ADDENDUM

Project: CCCL Pharmacy Fire Alarm Upgrade

Addendum No.: 1

AES Project No.: 23102-185, DCS #2307A

Sheet E0.01 Pharmacy Site Plan – Fire Alarm

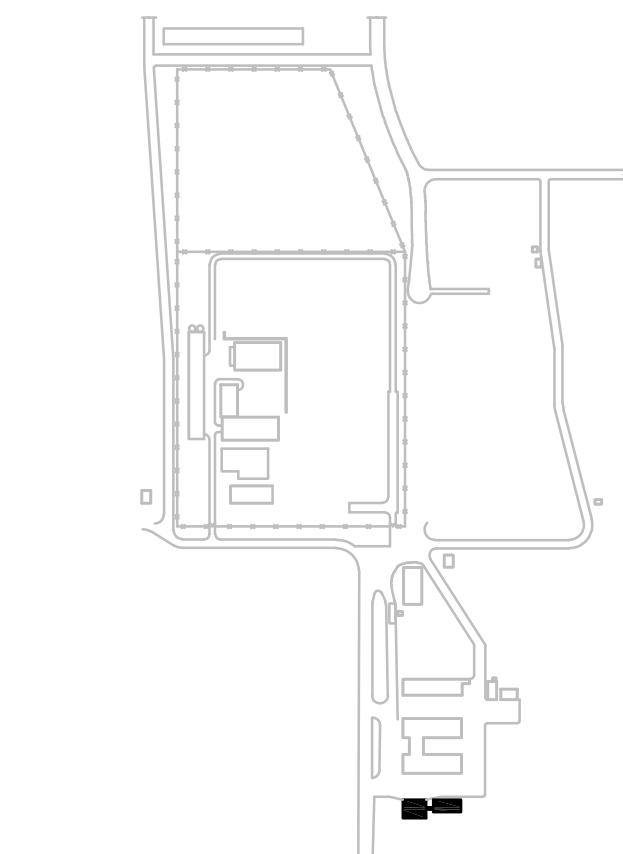
13. The Note 2 above clarification is shown in plan view.
14. The new underground conduit with inner duct and fiber shall be installed at the alternate location in the floor mounted rack. See attached drawing.
15. Note 4 revised to say – "THIS WORK TO BE DONE UNDER THE CCL MAINTENANCE FIRE ALARM PROJECT UPGRADE PROJECT, BY OTHERS."
